Access Compliance Report

Public Rights-of-Way

(Curb Ramps)

Intersection ID: 31760	Main Street: FIRST_RUN_CT	Cross Street: MONARCH_BIRCH_LN	Location: N
ADA ID: 1B80C3D24FCB	Ramp Type: PerpDiag	Initial Pass/Fail: Pass	Overall Compliance: No
Severity Score: 10.25			
Codes/Mitigation Info/Possible Solution		Field Measurements/Component Compliance

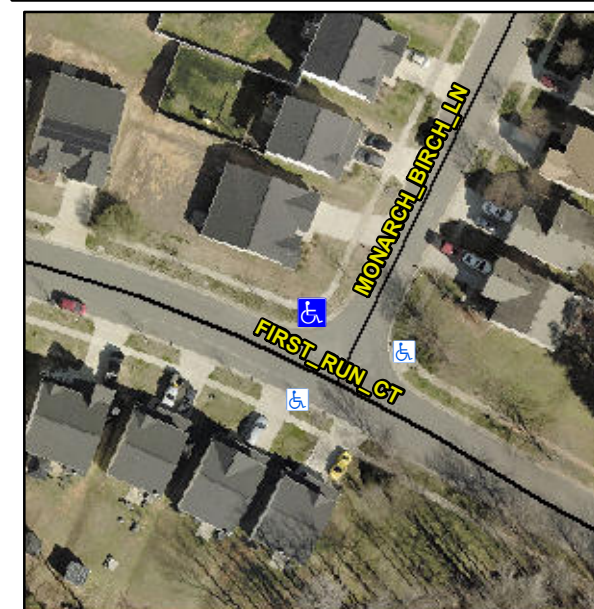
Not Found, R304.5.3, R304.2.1, R305.1.4, R305.2, R302.7.2

Compliance	Description	Data	Compliance	Description	Data
N/A	Ramp Length (in)	80.5	Yes	Ramp Slope (%)	7.1
Yes	Ramp Width (in)	57.5	No	Ramp XSlope (%)	2.2
Yes	Flare Type L	Curbed_NoWalkSurface	Yes	Flare Type RT	N/A
Yes	Flare Slope LT (%)	N/A	N/A	Flare Slope RT (%)	N/A
N/A	Flare Traversable LT?	No	N/A	Flare Traversable RT?	No
No	Landing Length (in)	47.0	Yes	DWS Provided?	Yes
Yes	Landing Width (in)	70.0	Yes	DWS Contrast?	Yes
Yes	Landing Slope (%)	1.5	Yes	DWS Length (in)	24.0
No	Landing X Slope (%)	3.7	No	DWS Full Width?	No
N/A	Landing Curb? (Y/N)	Yes	No	DWS Offset (in)	4.0
N/A	Shared Landing?	Yes			
Yes	Gutter Ponding?	No	Yes	Gutter Slope (%)	3.8
No	Gutter Lip Ht (in)	0.5	Yes	Gutter X Slope (%)	1.6
N/A	Painted X Walk1?	No	N/A	Painted X Walk2?	No
	X Walk 1 Direction	To SW		X Walk 2 Direction	To SE
N/A	X Walk 1 Width (in)	N/A	N/A	X Walk 2 Width (in)	N/A
	X Walk 1 Slope (%)	1.0		X Walk 2 Slope (%)	2.0
	X Walk 1 X Slope (%)	1.2		X Walk 2 X Slope (%)	4.3

N/A	Ramp inside XWalk1?	N/A	N/A	Ramp inside XWalk2?	N/A
	Road Slope (%)	1.2	N/A	Clear Space?	Yes
	Road X Slope (%)	3.4	N/A	Clear Space to XWalk (in)	N/A
Yes	Any Obstructions?	No	Yes	Storm Grate/Utility Hazard?	No
	Obstruction Type			Storm Grate/Utility Type	
		N/A			N/A
			Yes	Surface Condition? (G/P)	Good

Remove & Replace Curb Ramp With Two New Directional Ramps or Equivalent.
